SERVICE BULLETIN

Issue Number: SB-17-8-1

Subject: 2-Pin Bridle

Squirrel Harness/Container System Bridles (Pre Aug 27 2017).

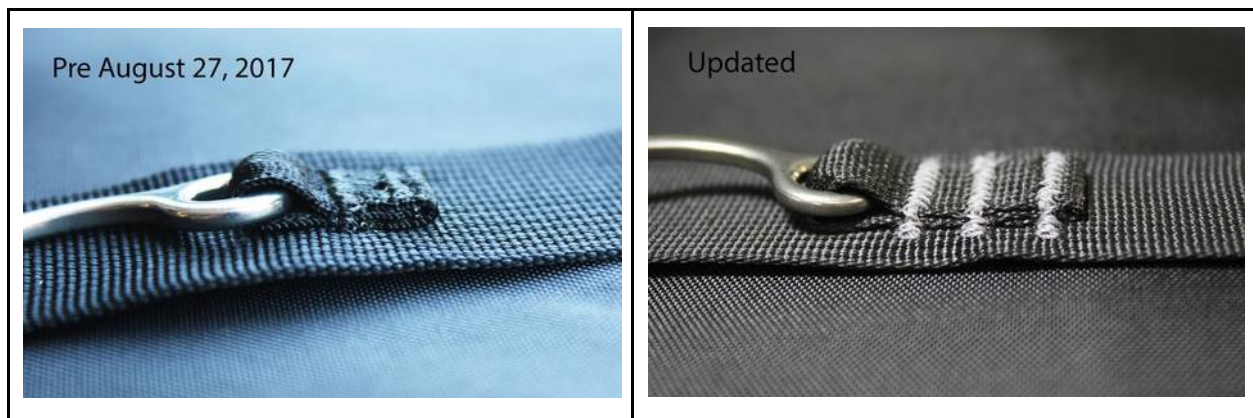
A recently delivered CRUX bridle suffered a pin hanger-loop failure. The pin detached prior to first use, during packing. All available evidence suggests that this manufacturing defect was a singular occurrence and no other bridles are affected. However, the pin-hanger junction may be difficult to inspect and verify that all layers of webbing are captured by the bartack, due to the closeness of the bartacks and length of the pin-hanger webbing.

Prior to next use, inspect the bridle pin-hangers. If there is any uncertainty in the integrity of the pin-hanger assembly, stop use and contact Squirrel to obtain a replacement bridle. Replacement bridles constructed after August 28, 2017 are built to an updated design, allowing for easier inspection. Replacement bridles can be delivered in a matter of days to any affected owner. Contact Squirrel LLC for shipping of a replacement bridle at no charge.
